Access Compliance Report

Public Rights-of-Way (Curb Ramps)

| Intersection ID: 27673 | Main Street: GUNPOWDER_POINT_DR | Cross Street: NOLEN_LN | Location: SE |
| ADA ID: C3E3A4B0C215 | Ramp Type: BlendTrans1 | Initial Pass/Fail: Fail | Overall Compliance: No |

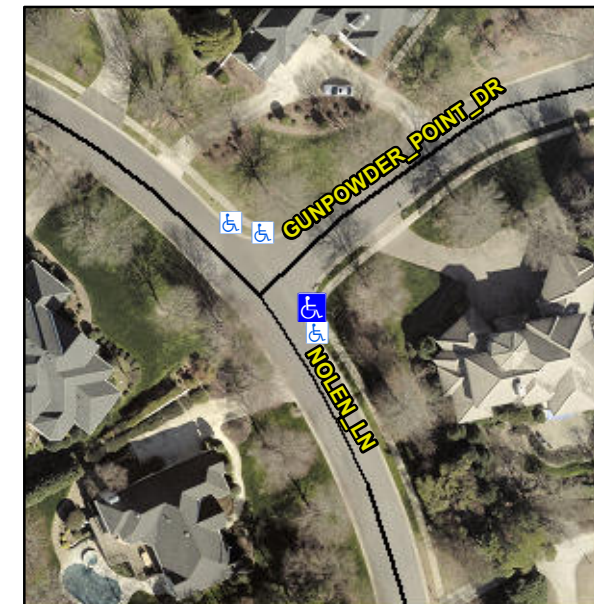
Not Found, R304.5.1, R304.5.3

| Compliance | Description | Data | Compliance | Description | Data |
|------------|-----------------------|-------|------------|-----------------------------|------|
| No | Ramp Width (in) | 43.0 | No | BlendTrans XSlope (%) | 8.8 |
| | | | No | Curb Slope (%) | 15.3 |

Remove & Replace Curb Ramp With Two New Directional Ramps or Equivalent.
